MAINTENANCE BULLETIN

AN/TPQ-37 (V4) ANTENNA TRANSCEIVER GROUP	FILE NO: 141	REVISION:
	DATE: 9/5/91	CATEGORY: D-SAFETY
SUBJECT: MISSING SLEEVING INSULATION ON BSU AND RECEIVER EXCITER POWER SUPPLY CONNECTOR CONTACTS	SYSTEMS AFFECTED: 89-99 (FMS ONLY)

RECEIVER EXCITER POWER SUPPLIES

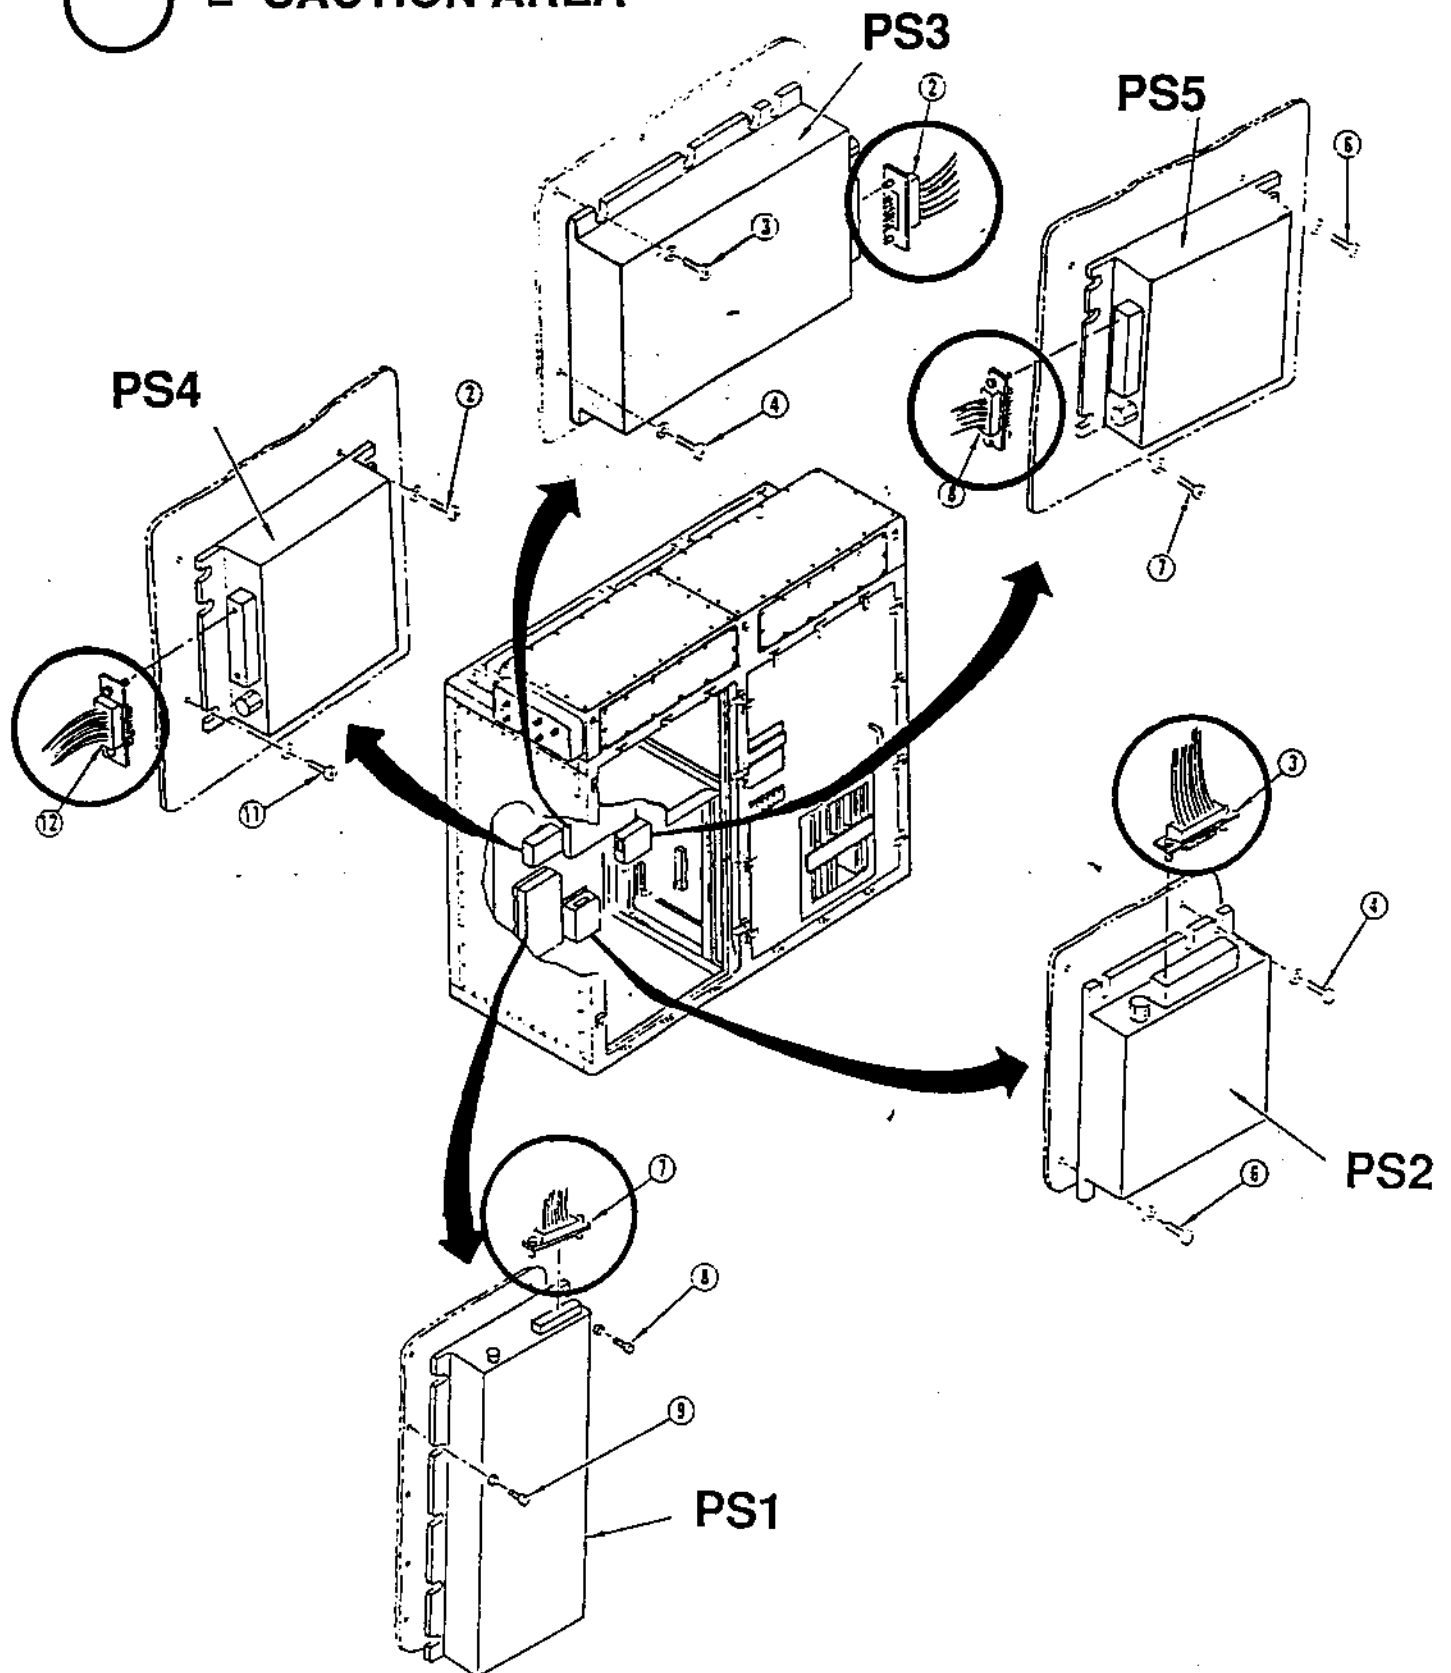
2. PURPOSE: The purpose of this SAFETY Bulletin is to alert the users of missing insulating sleeving on Beam Steering Unit (BSU) and Receiver Exciter Power Supply connector contacts. These exposed wires carry system AC Power (115V, 400Hz) as well as DC Power (-5 to 100V), thus presenting a possible SAFETY hazard when maintenance is being accomplished within the vicinity. Enclosed for ease of identification of the area within the BSU (P420, P421, P422, P423, P424, P425, P426, and P427) and Receiver Exciter (P9, P10, P11, P12, and P13) affected, find art work that has been extracted from reference in paragraph 1 above.

are being removed from the equipment as a SAFETY precaution. Technical personnel should be CAUTIONED about this SAFETY problem while they perform troubleshooting/maintenance around the subject surrounding areas.

● ○ = CAUTION AREA

BEAM STEERING UNIT POWER SUPPLIES

○ = CAUTION AREA

4. CORRECTIVE ACTION: The long term corrective action to alleviate above problem is now under consideration. After the final solution to this problem is arrived at, detailed documentation will be forwarded to the field for implementation.
